IMPORTANT SAFETY RECALL

August 2021

- Your vehicle is involved in GM safety recall N212340735.
- Install the enclosed label or schedule an appointment.
- This service will be performed for you at **no charge**.

Payload Modification Label Installation Instructions:

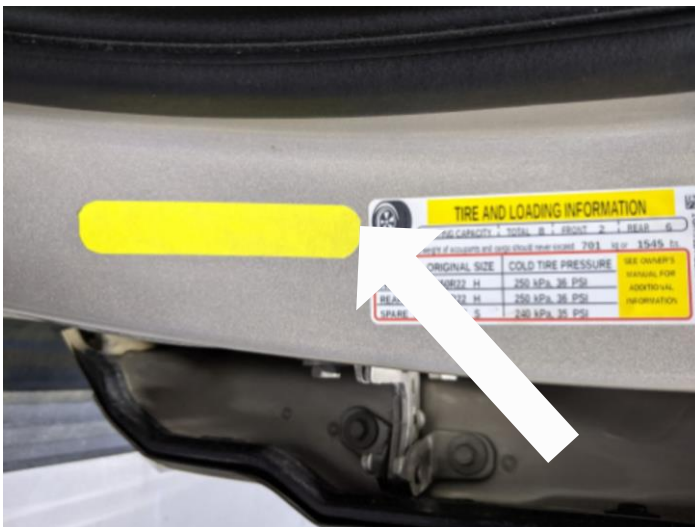
The vehicle capacity weight printed on the Tire and Loading Information placard is 22.5 kg (51 lbs.) more than intended. Loading in excess of the correct vehicle capacity weight may affect driving dynamics under certain conditions, increasing the risk of a crash.

The Cargo Carrying Capacity Reduced label for your vehicle is enclosed. To reduce your inconvenience, you can install the label easily by following the enclosed instructions. If you desire, however, you may take the label to your dealer for installation within the next 60 days. This service will be performed for you at **no charge**.

TIRE AND LOADING INFORMATION			
SEATING CAPACITY	TOTAL 3	FRONT 3	REAR 0
The combined weight of occupants and cargo should never exceed 1602 kg or 3532 lbs.			
TIRE	ORIGINAL SIZE	COLD TIRE PRESSURE	SEE OWNER'S MANUAL FOR ADDITIONAL INFORMATION
FRONT	LT265/70R18ER	420 kPa, 60 PSI	
REAR	LT265/70R18ER	550 kPa, 80 PSI	
SPARE	LT265/70R18ES	550 kPa, 80 PSI

1. Locate the Tire and Loading Information label on the "B" pillar in the driver side front door jamb.

2. Clean the mounting surface using isopropyl alcohol and dry with clean, lint free cloth. Receiving surface MUST be clean, dry and free of any contaminants.
3. Firmly hold the new label and peel protective liner from the back side, being careful not to touch or contaminate the adhesive with dirt or foreign matter.

4. Carefully align the top edge of the new label to the existing Tire and Loading Information label. Press firmly and smooth out entire label ensuring corners are fully adhered.
